Safety Defect and Noncompliance Report Guide for Equipment

PART 573 Defect and Noncompliance Report

Model: RACK and ROLL Trailer

Part Number: 8008106 and 8008107 **Size:** 66"/250 lb and 78"/300 lb (crossbar width/weight capacity)

7C Grease Wheel Axle Bolt before and after insertion

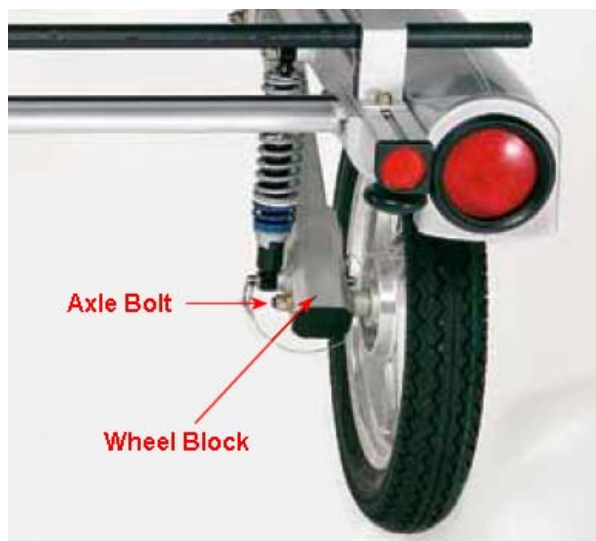
The wheels (left and right) are secured onto the Wheel Blocks using an Axle Bolt, flat washer, lock washer, and hex nut. Yakima's concern is that no safety pin/trapped nut of any type is being used beyond the use of a lock washer, which could potentially lead to a wheel becoming separated from the trailer while in use.

Design of axle bolt assembly does not provide a safety retention device, such as a cotter pin or captured nut.

We will be supplying the consumers with a bolt kit that will include a new axle bolt, castle nut, and cotter pin, and clear instructions for replacing their current axle bolts. The difference between the recall condition and the remedy is that the remedy will include a cotter pin and castle nut to ensure that the wheel cannot come free from the Wheel Block.

New design will contain a slotted, castle nut with a cotter pin through the bolt to prevent the nut from turning.
